**PLANNING COMMISSION
SITE PLAN REVIEW
CASE SUMMARY**

**350 WAYNE STREET
USC DEVELOPMENT FOUNDATION
USC COLUMBIA INCUBATOR**

Subject Property:	350 Wayne Street
TMS#:	08913-04-01, 08913-03-06 and -07
Zoning District:	M-2, -PD (Heavy Industrial within the Planned Development Overlay District)
Council District:	2
Proposal:	Request site plan approval for the construction of a ± 50,000 sq. ft. building.
Applicant:	USC Development Foundation
Proposed Use:	Research Incubator (8731)
Staff Recommendation:	Approval with staff comments.

BOOK 89B-25	SF NO. 194-21
PROJECT NO. 1898	SHEET NO. C2
DATE 6/03/2016

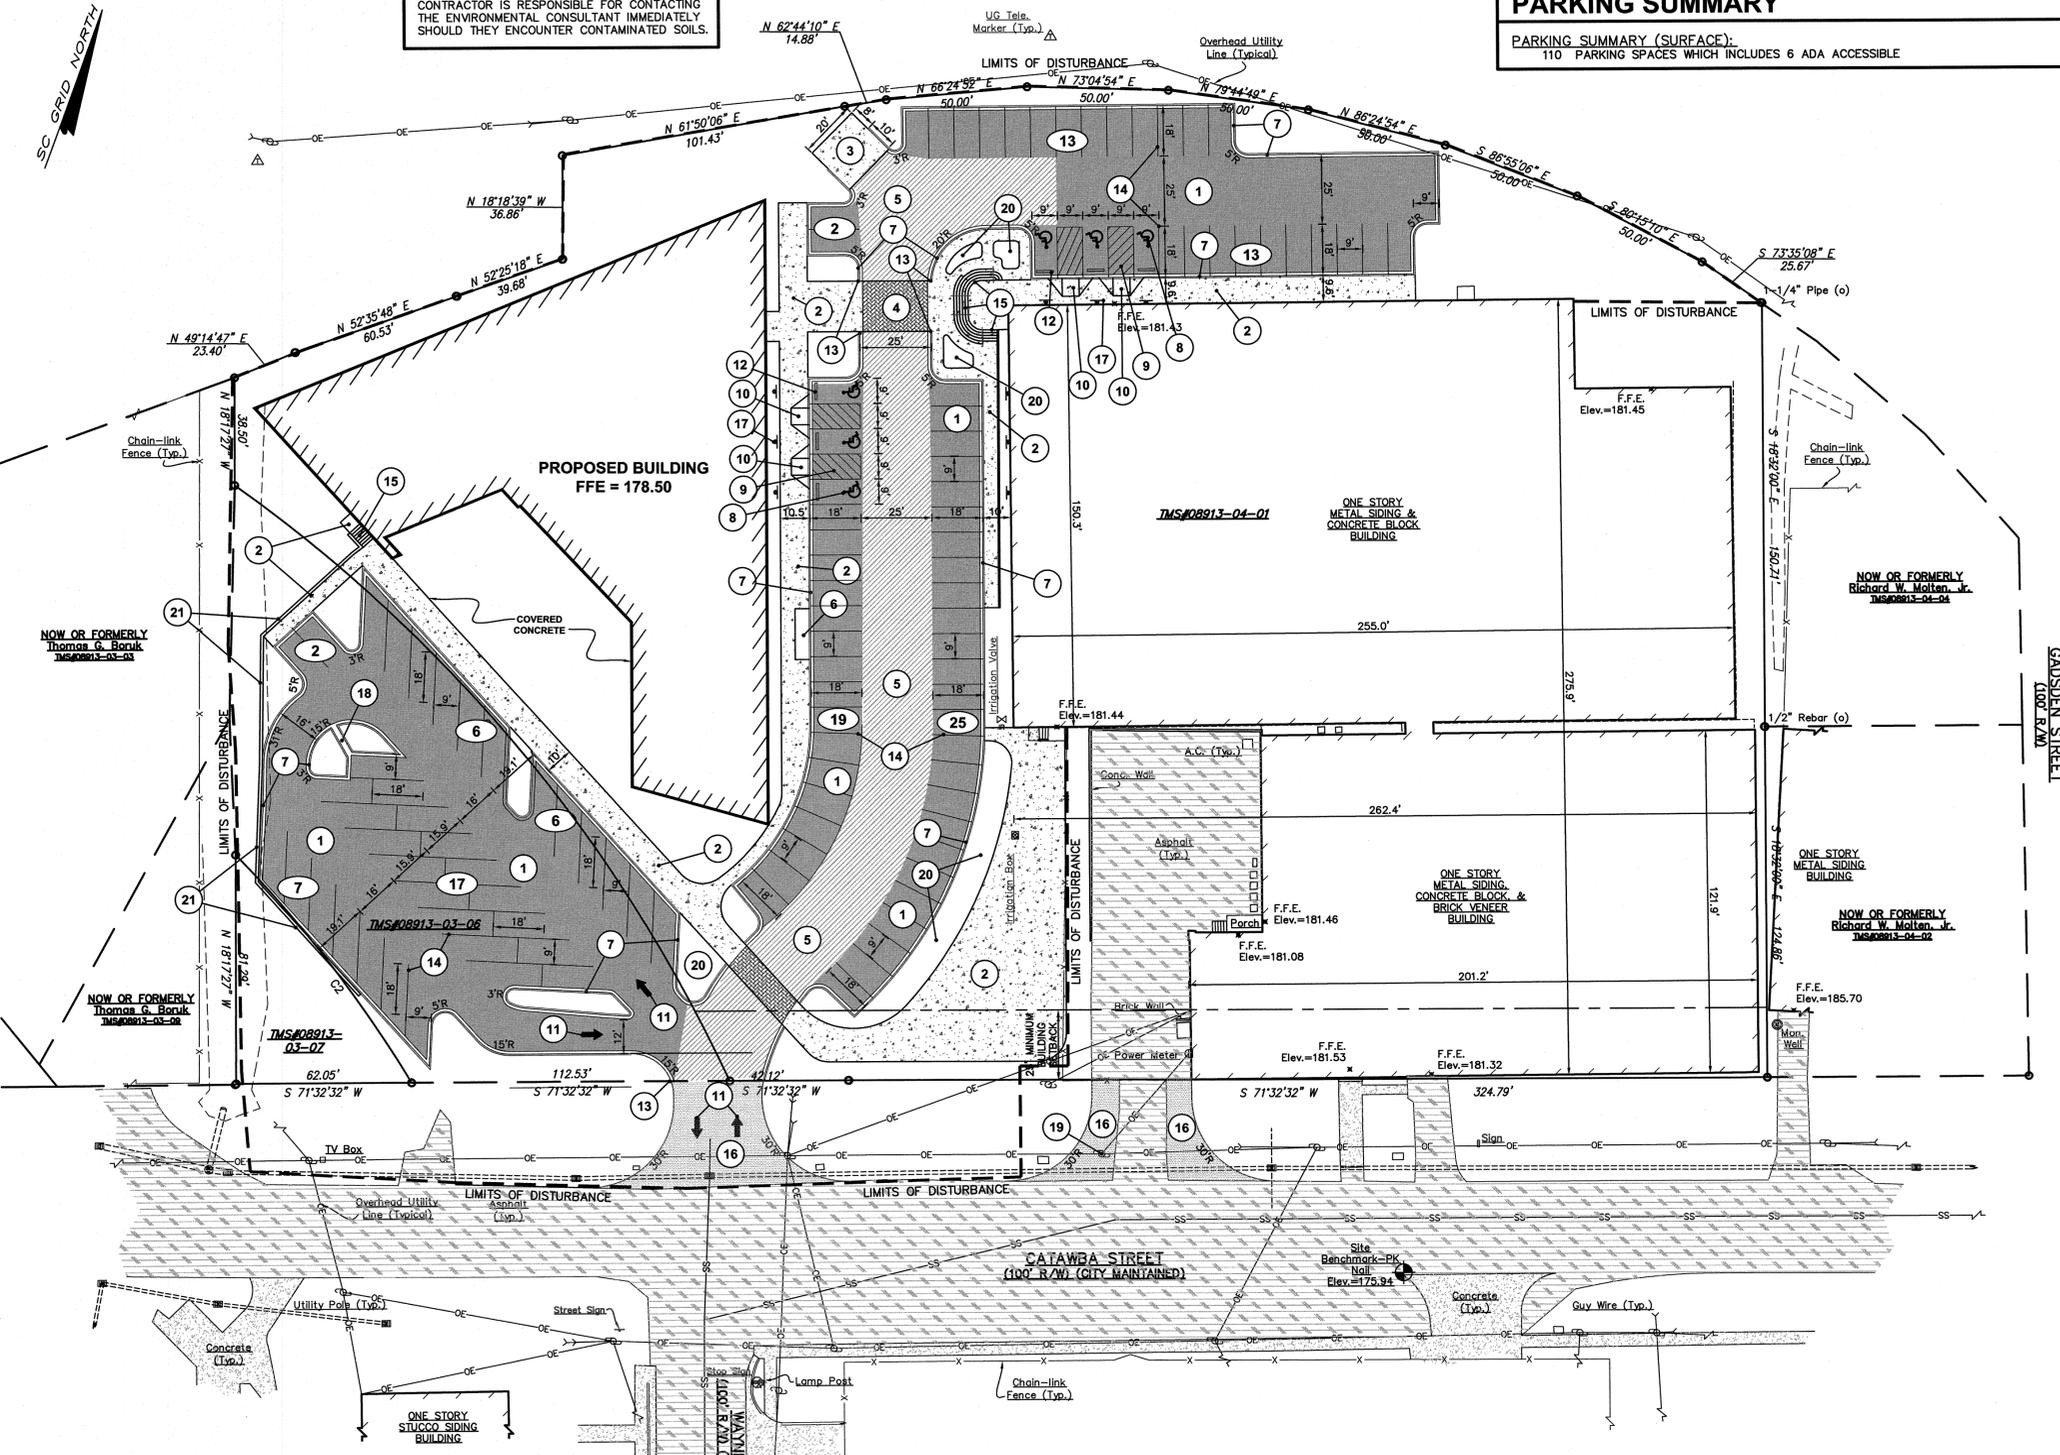
John Fellows, Planning	<p>Recommend approval with conditions:</p> <ol style="list-style-type: none"> 1. Sidewalks shall be provided along the north side of Catawba Street separated from the road with a planting strip per city standards. 2. Connectivity from the internal sidewalk system to the public sidewalk system shall be provided. 3. The intersection of Catawba, Wayne, and the driveway to the development shall be configured as an intersection with crosswalks on Catawba to allow this development to connect to the pedestrian system of the surrounding neighborhood. Thermo crosswalks with high visibility markings shall be provided. 4. Details of the Sidewalk and driveway shall be similar to SCDOT
-------------------------------	--

standard Drawing 720-415-00 (Driveway with Separated sidewalk...) to all for continuous sidewalk for pedestrians.
K. Brian Cook, Zoning Administrator	Recommend approval with condition: <ol style="list-style-type: none"> 1. Available parking does not meet requirements. This approval is conditioned upon receiving a parking variance or other parking relief from the Board of Zoning Appeals.
Johnathan Chambers, Land Development Administrator	Recommend approval with condition: <ol style="list-style-type: none"> 1. City and State Encroachment permits will be required for work being conducted within the ROW. 2. Project spans three separate parcels with two separate ownerships. Site plan may need to be reconfigured such that parking spaces are totally contained on separate parcels. 3. Cross access easements shall be reviewed and approved prior the issuance of any building permits.
Jerry Thompson, Building Official	Recommend approval with condition: <ol style="list-style-type: none"> 1. Must comply with all applicable building codes.

Scott Rogers, Utilities	Recommend approval with conditions: <ol style="list-style-type: none"> 1. Any needed upgrade, extension or relocation of City utilities must be provided by the developer. 2. Any privately owned/maintained utilities or permanent structures cannot be located inside City of Columbia utility easements. 3. Water mains, sewer mains, water meters that are 4" or larger or any privately maintained utilities will not be allowed inside public right-of-ways or under sidewalks without an approved encroachment permit and written approval from the City Engineer. Coordination between the Civil Engineer, Architect and Mechanical Engineer to allow room for these utilities on the developed property is strongly encouraged. 4. If sewer flows for this project result in flows of 4,000 gallons per day or above calculations must be submitted to the City's Engineering department to determine how the proposed project will affect the City's sewer system. Depending upon the effects of the projected flows this project may or may not be approved. If required, these calculations should be submitted to the Engineering department as soon as possible.

David Brewer, Traffic Engineering	Recommend approval.
Kris Scott, Fire Department	Recommend approval.
Sara Hollar, Forestry	Recommend approval with condition: <ol style="list-style-type: none"> 1. If any new landscaping or irrigation is installed in the right of way, it must be approved by Forestry and Beautification and maintained by the adjacent property owner in a manner to not interfere with vehicular and pedestrian traffic. 2. SCDOT must approve any new landscaping installed along SCDOT roadways.
Mike Jaspers, Stormwater	Recommend approval with condition: <ol style="list-style-type: none"> 1. Jurisdictional determination from the Army Corps of Engineers may be necessary to delineate the edge of corps jurisdiction. 2. If water ways and or wetlands in or near the development are jurisdictional to the corps, City of Columbia buffer requirements will apply. 3. Design must meet all land disturbance requirements.

David Knoche, Parking	Recommend approval.
Robert Sweatt, Street Division	Recommend approval.
John Hooks, Solid Waste	Recommend approval.
Scott Holder, Landscaping	Recommend approval with conditions: <ol style="list-style-type: none"> 1. Detailed landscape plan to be provided. 2. Tree survey to be provided. Credit for existing trees will only be given

for existing trees shown on a tree survey. 3. Remaining tree credits to be allocated to the tree fund.
--	--
